**FINAL EXPRESS TERMS
OF PROPOSED BUILDING STANDARDS
OF THE DIVISION OF THE STATE ARCHITECT - STRUCTURAL SAFETY**

**REGARDING THE 2001 CALIFORNIA BUILDING CODE
CALIFORNIA CODE OF REGULATIONS, TITLE 24, PART 2**

Chapters 16A, 18A, 19A, 21A, 22A, and 23A

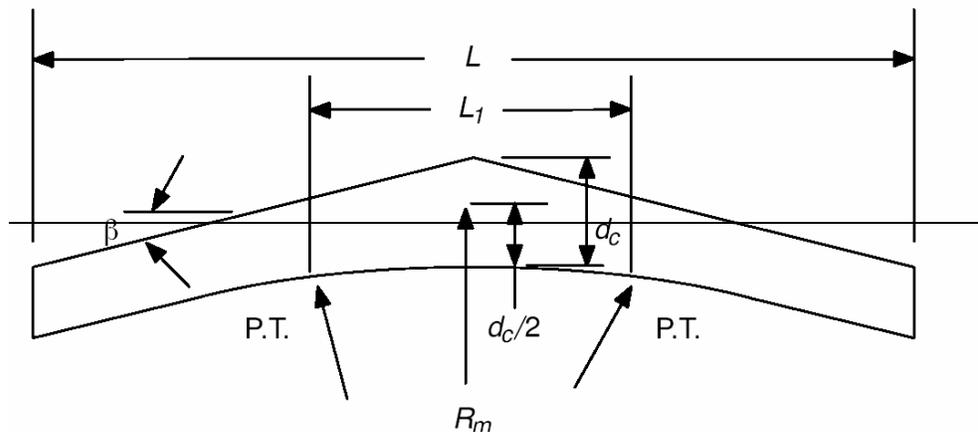
When the beam is loaded with a uniform load, K_r may be modified by multiplying by the reduction factor C_r as calculated by the following formula:

C_r = reduction factor.

L = span of beam.

L_t = length of beam between tangent points.
